ADDENDUM NO. 04

PROJECT NAME: McAllister Park
TCI PROJECT NO.: 40-00375
DATE: February 11, 2015

Item No. 4: Sheet L5.5 – Pavilion details

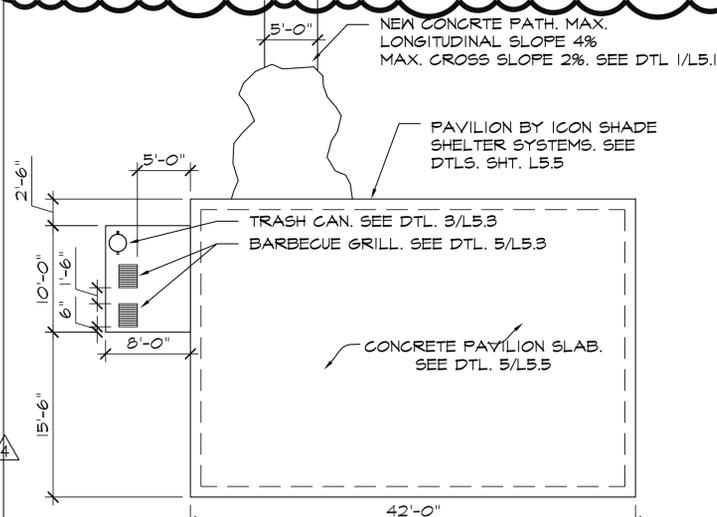
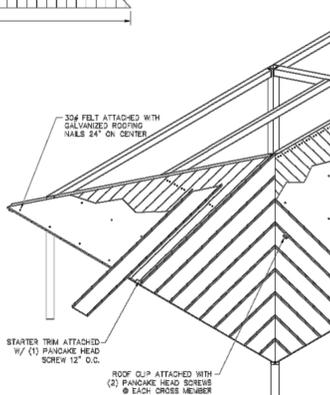
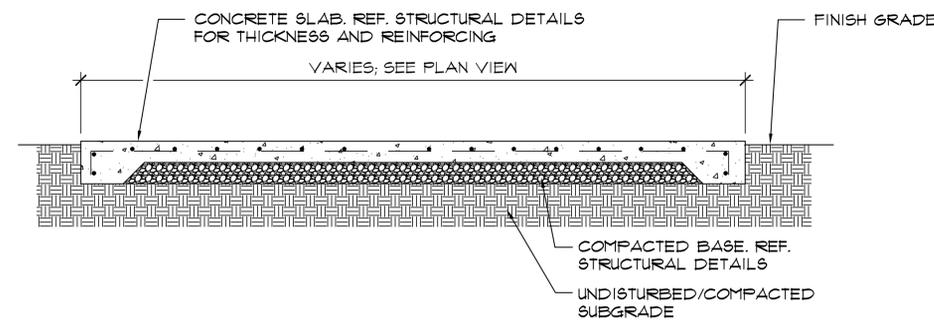
Tongue and groove decking is removed from the pavilion at the Dog Park/Practice Field. The correct product number for the pavilion is RH30x44S-P4, **not** RH30x44TS-P4.

Replace previously issued sheet, dated 11/20/2014, with attached revised and reissued sheet, dated **02/11/2015**.
